National Fire Protection Association

MEMORANDUM

SUBJECT: NFPA 1981 ROP TC Letter Ballot (F2012)

Attachments: Proposals
Letter Ballot

Figure 8.10.4.9 (a) Hemi-Anechoic Chamber 1

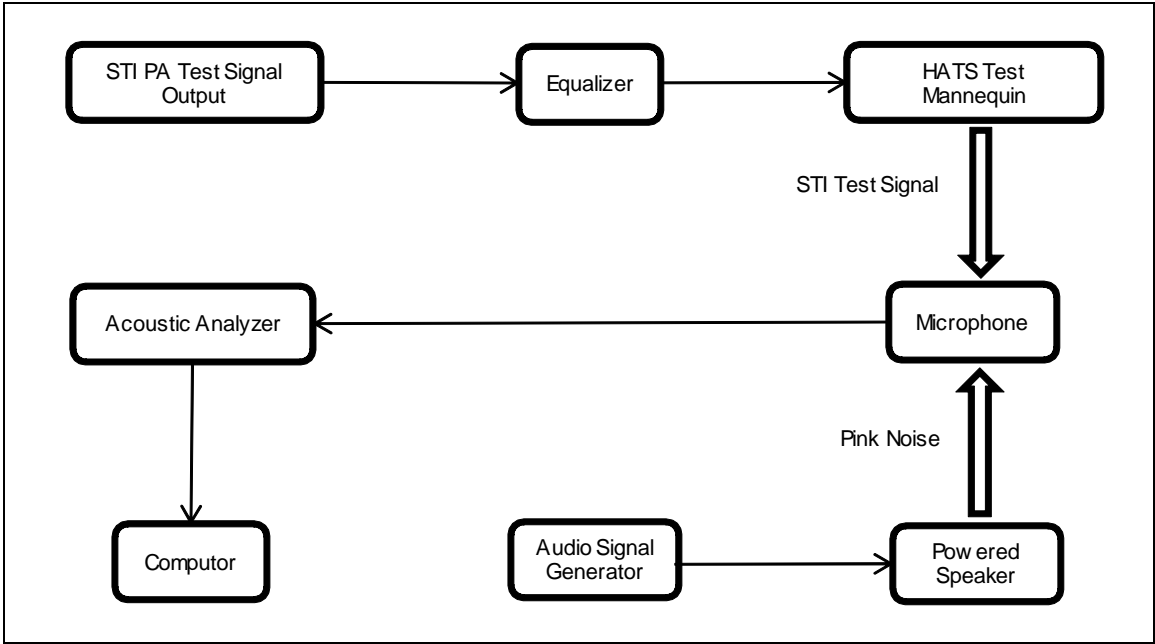
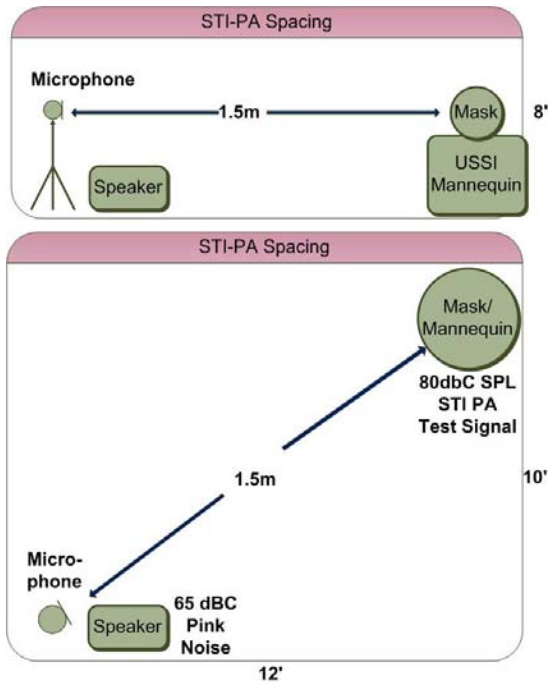
~~***Insert Figure 8.10.4.9(a) Hemi-Anechoic Chamber***~~

~~***Insert Figure 8.10.4.9(b) Hemi-Anechoic Chamber***~~

~~8.10.5.1 The method for measuring speech transmission index ~~word intelligibility~~ shall be as specified in ANSI S3.2, Method for Measuring the Intelligibility of Speech over Communication Systems IEC 60268-16:2003, Sound System Equipment – Part 16: Objective Rating of Speech Intelligibility by Speech Transmission Index, using the STI-PA technique, with the modified apparatus specified in 8.10.4.~~

Figure 8.25.4.9 (a) Hemi-Anechoic Chamber 1

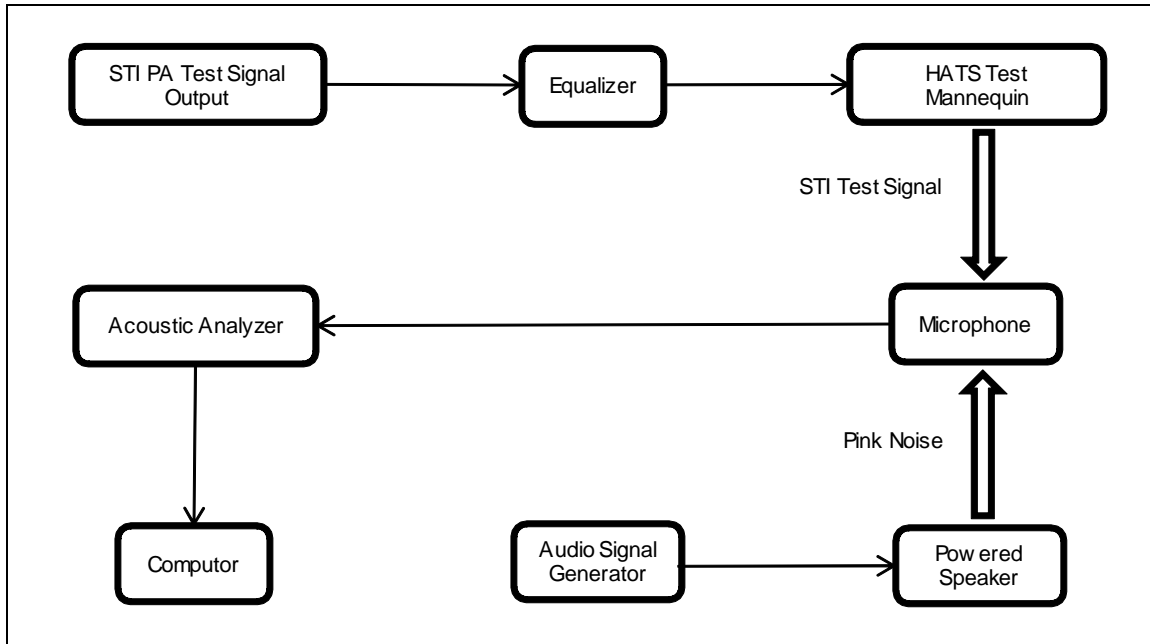
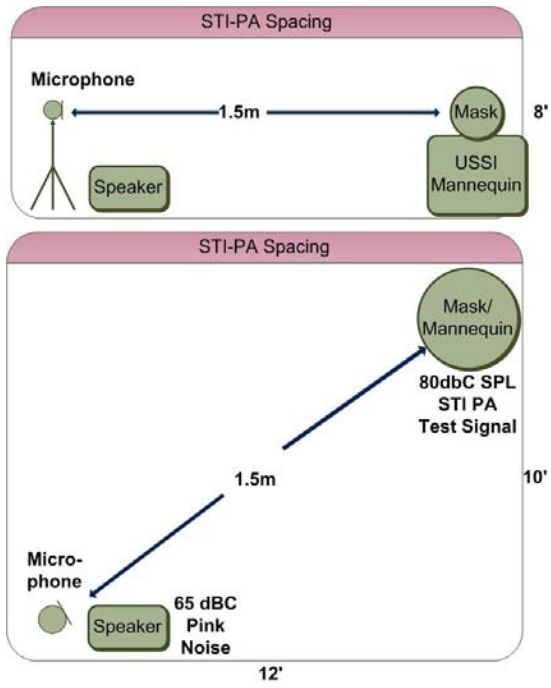
~~8.25.4.9 All of the apparatus identified in 8.25.10.4.2, 8.25.4.3, 8.25.4.4, 8.25.4.5, 8.25.4.6, 8.25.4.7 shall be located in the hemi-anechoic chamber (Reference Figure 8.25.4.9a and 8.25.4.9b).~~

*** Insert Figure 8.25.4.9(a) Here***

*** Insert Figure 8.25.4.9(b) Here***
